MCLEOD FAMILY DIVISION SUBDIVISION

APPLICATION NUMBER 4 DATE August 2, 2018

DETAIL SITE PLAN

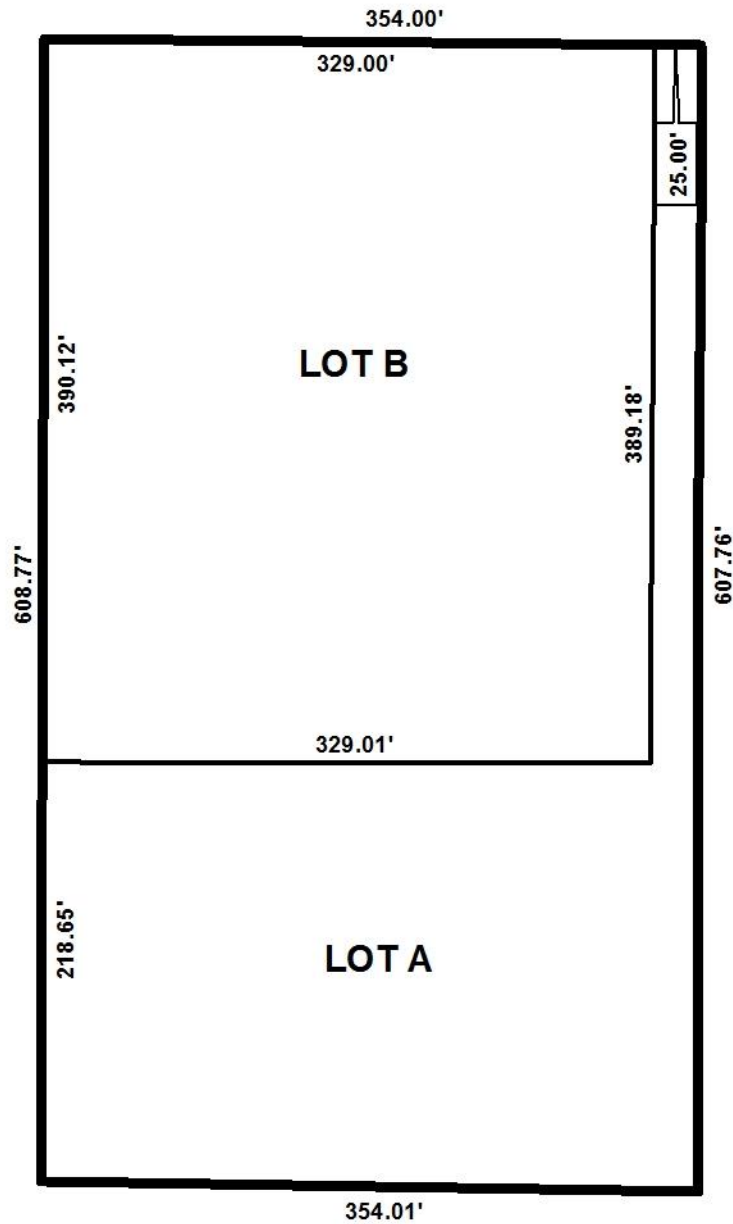
The proposed lots have frontage on Seaman Drive, a private, unpaved minor street requiring a 60' right-of-way. Sufficient right-of-way is illustrated on the preliminary plat and should be retained on the Final Plat, if approved.

The 25' minimum building setback is not illustrated on the preliminary plat, as required by Section V.D.9. of the Subdivision Regulations. As such, revision of the plat to illustrate the 25' minimum building setback along Seaman Drive where each lot is at least 60' in width should be required, if approved.

Lot A is irregularly shaped and may be regarded as a “flag” lot, a design generally discouraged by Section V.D.1. of the Subdivision Regulations unless there are pre-existing barriers, or in the case of a family subdivision. If approved, the division of the parcel between family members makes a waiver of Section V.D.1. appropriate.

Irrespective of the design of the lots, they each meet the minimum size requirements for lots served by public water and individual septic systems; however, their sizes are labeled only in acres and not in square-feet. As such, revision of the plat to indicate the size of each lot in both square-feet and acres should be required, if approved; or, provision of a table on the Final Plat providing the same information may suffice.

The vicinity map on the preliminary plat is hand drawn and may not properly reflect the location of the proposed subdivision. As such, revision of the vicinity map to properly identify the location of the proposed subdivision should be required, if approved.
